RE: Tin Can Alley
6100 Alameda NE
Grading and Drainage Plan
Engineer's Stamp Date: 02/20/19
Hydrology File: C18D086

Based upon the information provided in your submittal received 02/20/2019, the Grading and Drainage Plan **is not** approved for Building Permit and Foundation Permit. The following comments need to be addressed for approval of the above referenced project:

**RE: Alameda Development
6100 Alameda NE
Conceptual Grading and Drainage Plan
Engineer's Stamp Date: 09/12/18
Hydrology File: C18D086**

Project: **Alameda & San Pedro Mixed Use Development**
6100 Alameda NE
Albuquerque, New Mexico

Grading and
Drainage Plan
date:
2-20-19
sheet:
c101

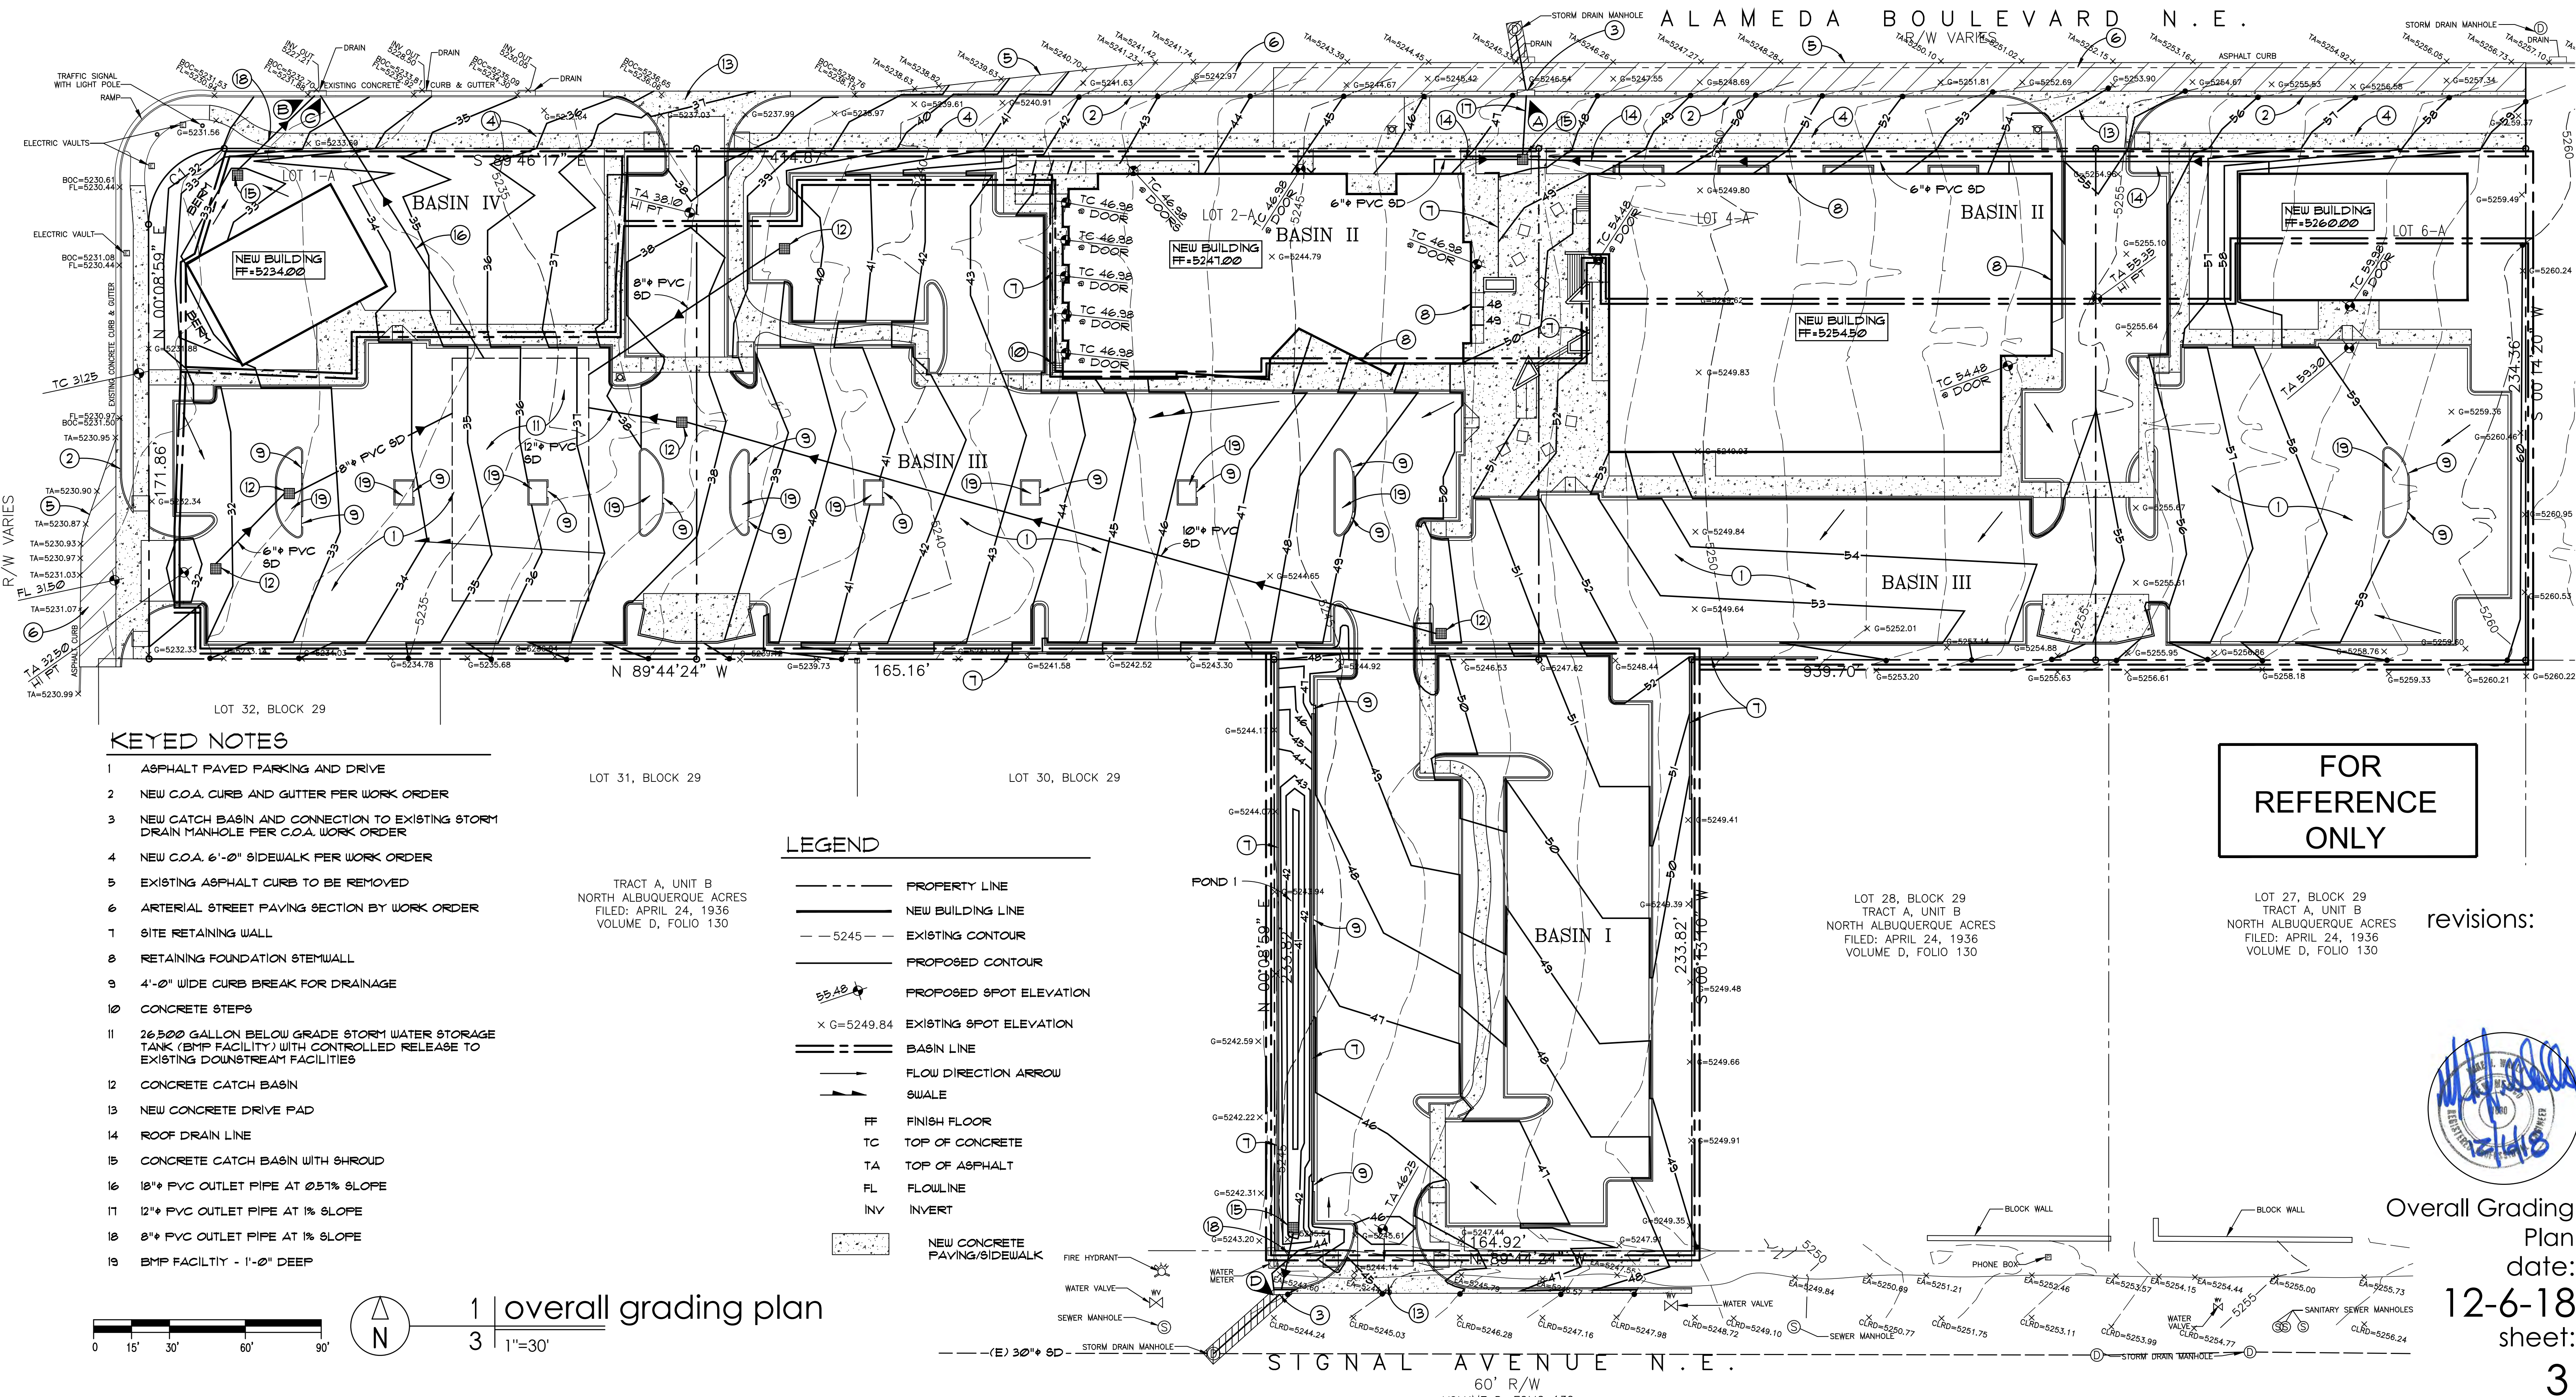
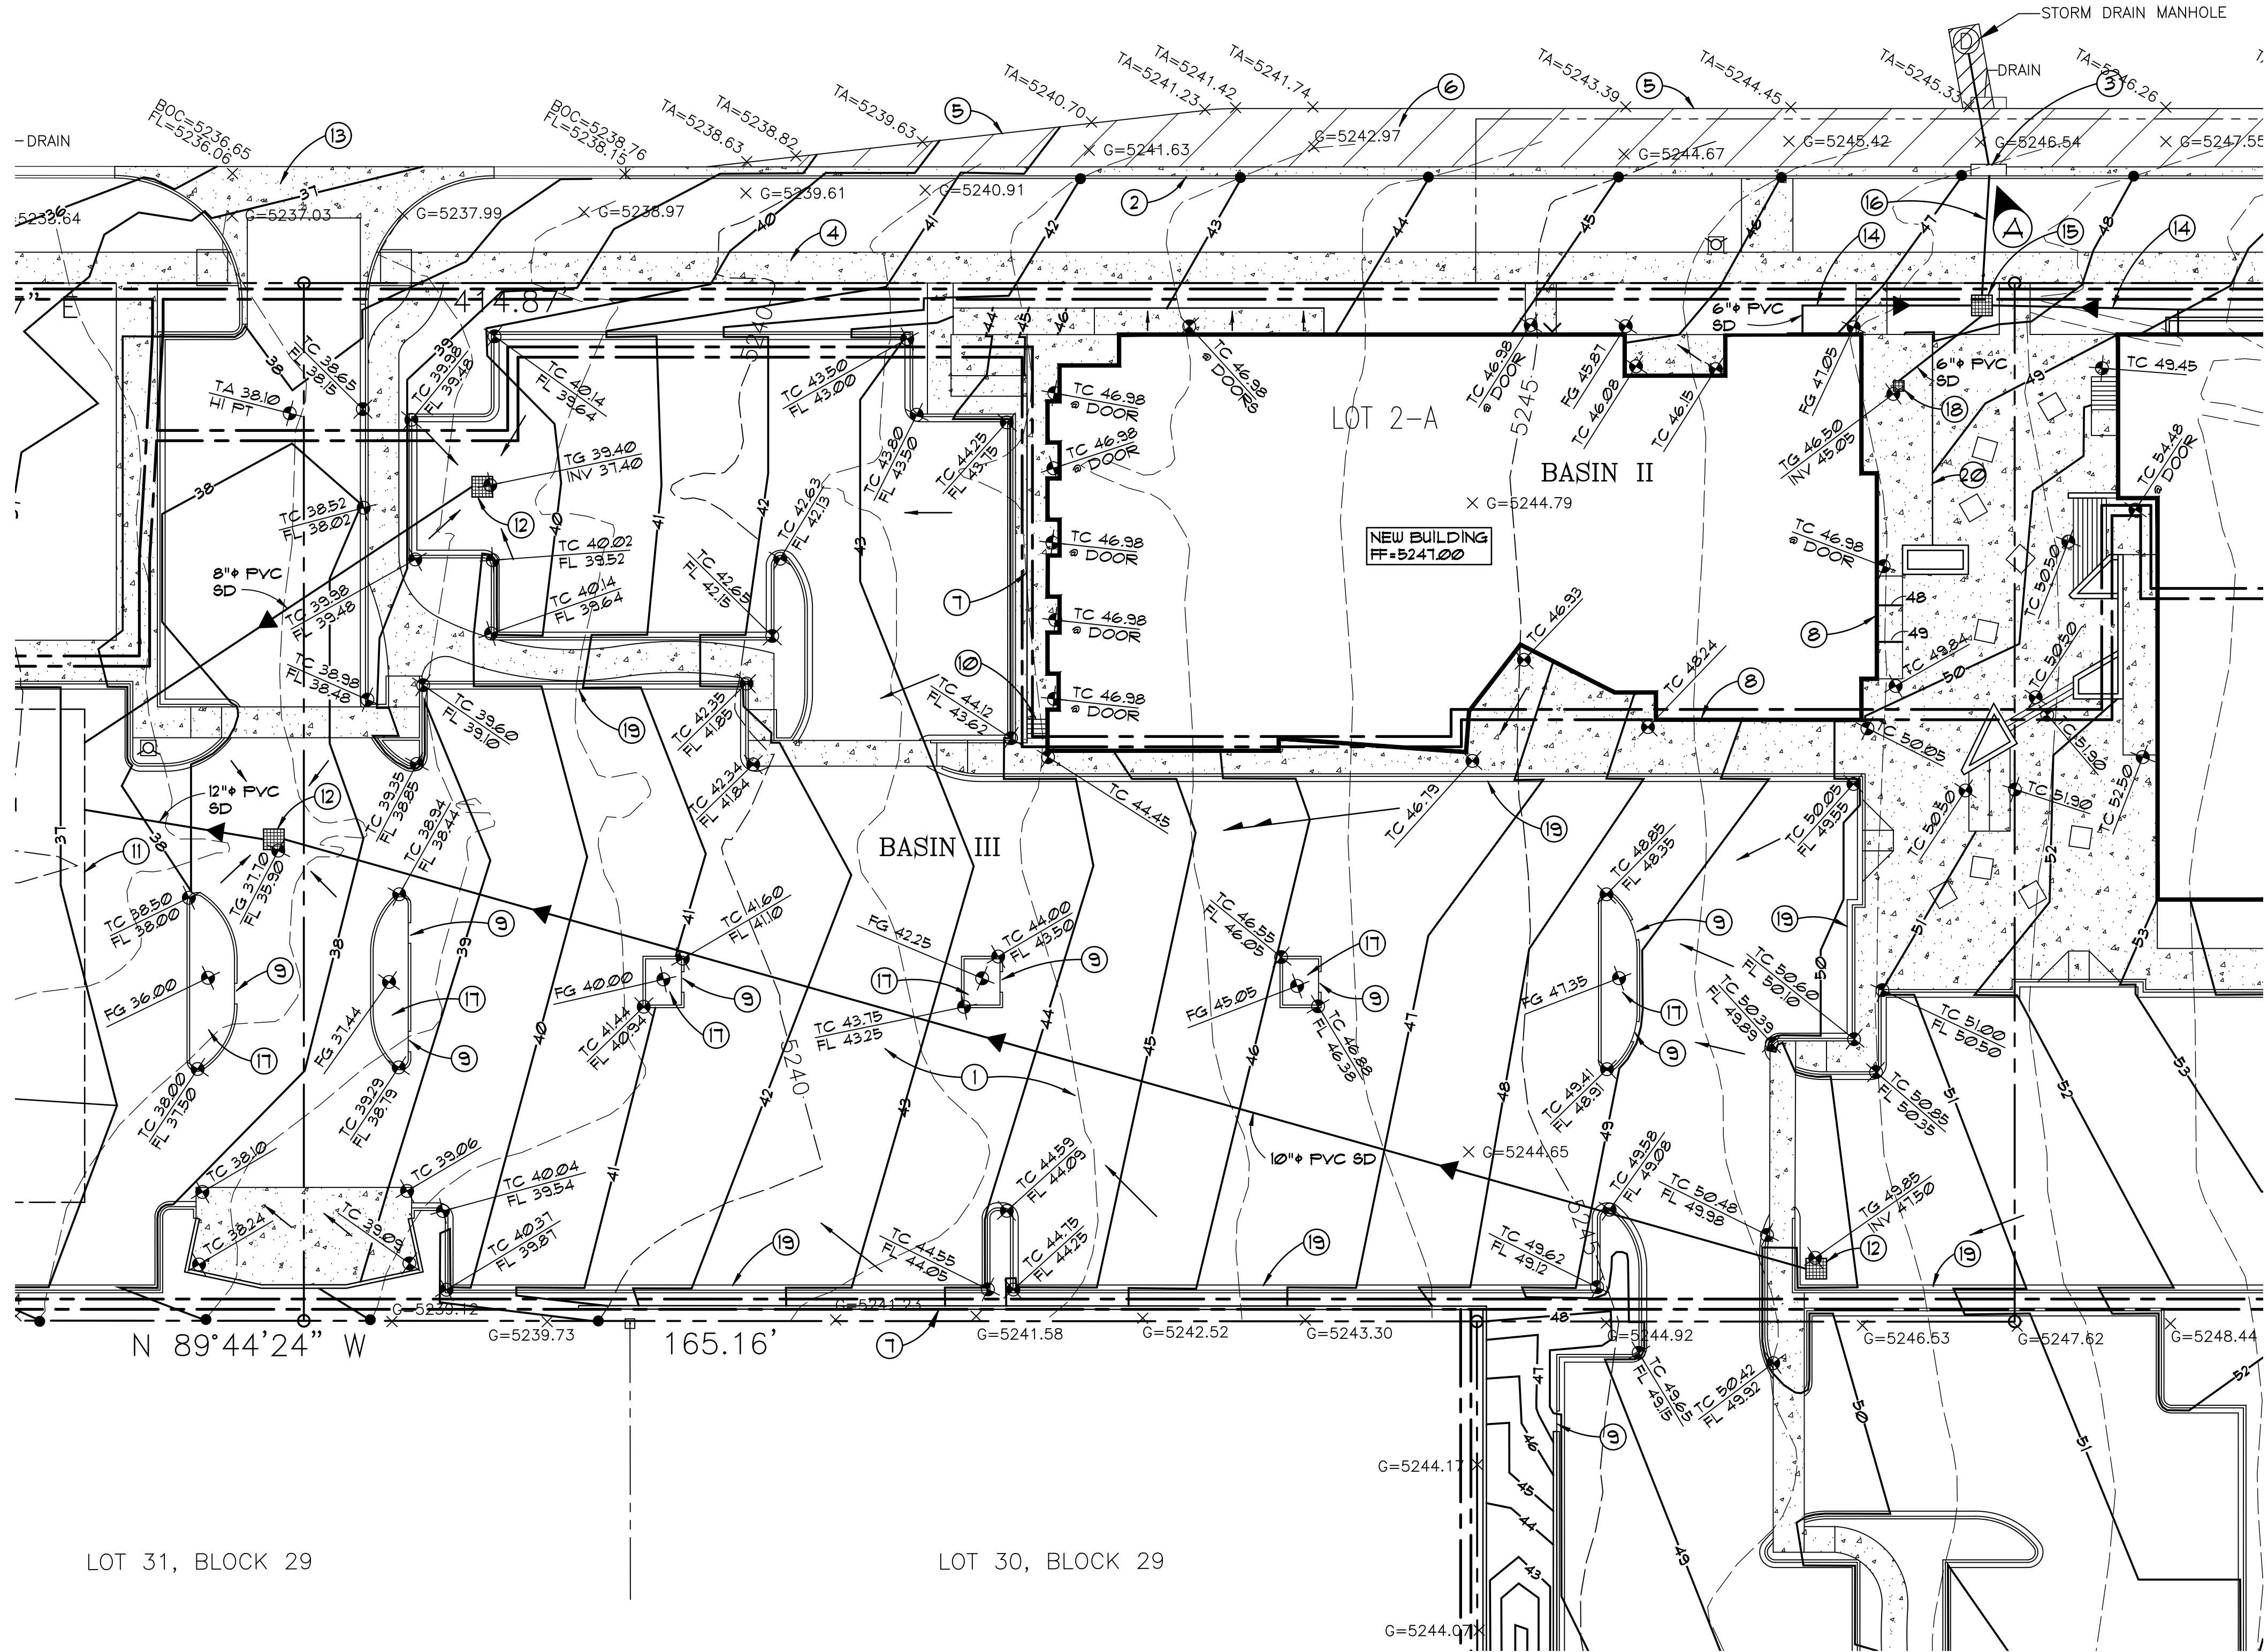
1. Overall G & D. Please show what is being constructed with this Building Permit (the limits of construction). Will a permanent drainage system or a temporary retention pond (100 year 10 day volume) be constructed? Whichever the solution is built, please include this in the construction plans.

2. Overall G & D. Please show and label all work within the R.O.W. as being constructed under CPN # 766382.
3. Overall G & D. Please show all future development with a lighter linetype and label as future development.

4. Please also show the parking spaces along with the ADA spaces.
5. Please show the trash enclosures. For trash enclosures serving food service developments, demonstrate control of liquids from dumpster areas per DPM Chapter 22.9.E, Table 1 by containing runoff from the dumpster area and discharging to the sanitary sewer. If this information is on the utility plan please provide it, or show on the grading plan.

12. Please show a buildable underground detention facility with all needed details.
13. Please include all calculations for the outfall structure/orifice plate whichever is being used to limit the discharge rate.

14. Please show how the runoff from the proposed phased paving area is going to be stopped from traveling to the adjacent undeveloped area. Also provide any supporting hydrologic calculations.

15. Please revise the Hydrologic Grade Line (HGL) calculations for the proposed storm system from the existing storm drain truck line in Alameda through the underground system to the sump inlet near the drive entrance to San Pedro Blvd. Using DPM procedures including Bernoulli's equation and minor losses applied to the energy grade line. Also Include the Energy Grade Line (EGL) elevations. The normal depth calculations submitted in the Conceptual G&D Plan are not adequate for the final construction plan approval.
